**ADDENDUM NO. 1
TO CONTRACT DOCUMENT PLANS SPECIFICATIONS**

**PROJECT: MWA METRO PARK EAST LANDFILL
P-65 CELL F LINER CONSTRUCTION**
TO: PROSPECTIVE BIDDERS AND OTHER INTERESTED PARTIES

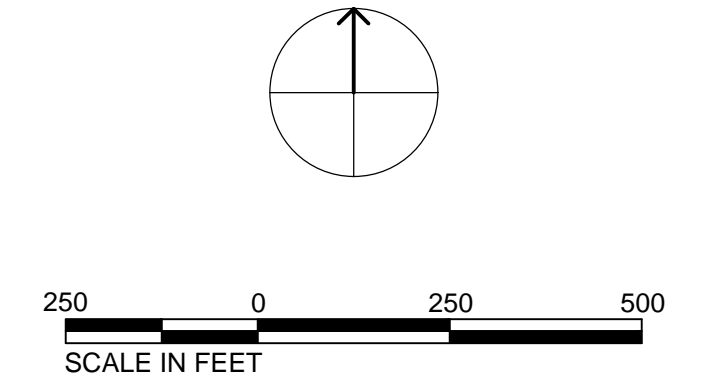
AD-1 Item 5 CELL EXCAVATION STOCKPILE AREAS

- A. ADD the attachment within this Addendum No. 1 including a figure detailing plan stockpile areas and their capacities for the excavated material from Cell F Construction.

Question 2: Where can vegetation removed from the sediment ponds during the execution of Alternate Bid Items 117 and 118 be stockpiled or placed?

Answer 2: Proposed stockpile location of removed vegetation shown on the cell excavation stockpile areas figure (Item 5) of this addendum.
